**Re: Altera 769, LLC
Application for Preliminary and Final Major Site Plan Approval
769 Northfield Avenue – Block 166.15, Lot 1.09**

**RE: 769 Altera, LLC
Proposed Site Improvements
Block 166.15, Lot 9
769 Northfield Ave (CR 508)
Township of West Orange
Essex County, NJ
DEC #2530-99-006
Application No.: PB-21-10**

Memorandum from Township of West Orange Department of Planning and Development prepared by Paul Grygiel, AICP, PP, Planning Director dated February 8, 2022:

CME Associates Memorandum prepared by John J. Hess, PE, PP, CME dated February 9, 2022:

TITLE: **VEHICLE CIRCULATION
EXHIBIT - DELIVERY**

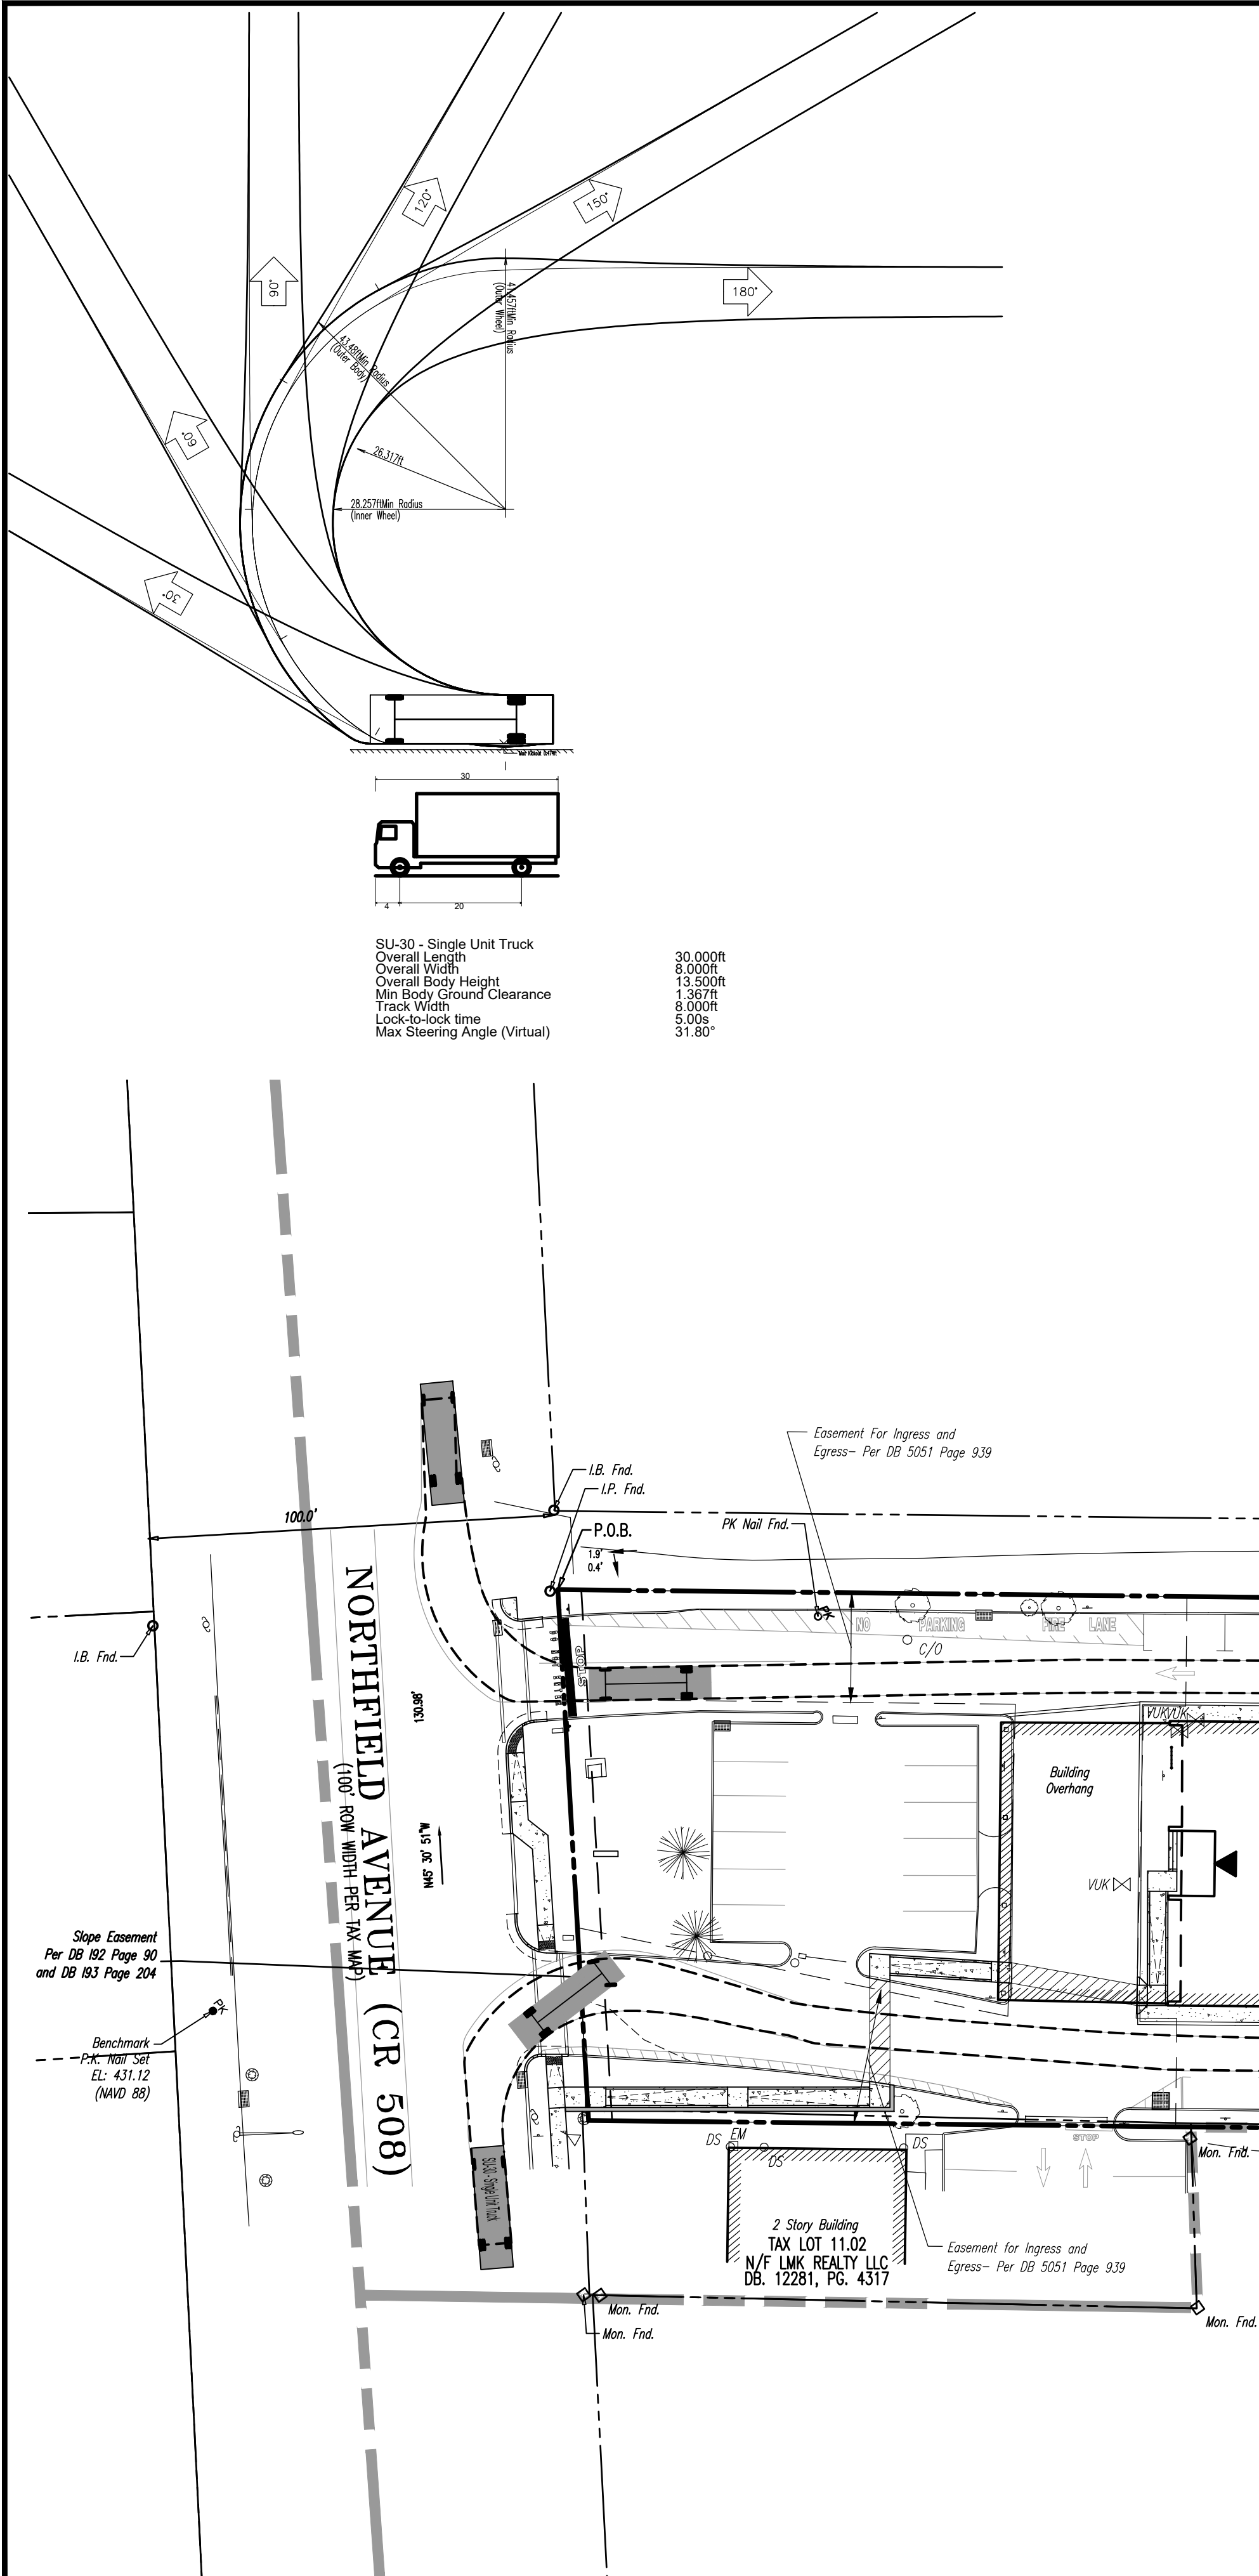
1. No response required.
2. Please refer to the Vehicle Circulation Exhibits enclosed within this submission. Phase 1 and Phase 2 propose a total of 226 and 282 parking spaces respectively. This equates to a requirement of total of 9 proposed electric vehicle parking spaces for Phase 1 and 11 for Phase 2. As shown in the enclosed exhibit 9 spaces are proposed for Phase 1 including 1 ADA space and an additional 2 for Phase 2 thus satisfying the 4% requirement.
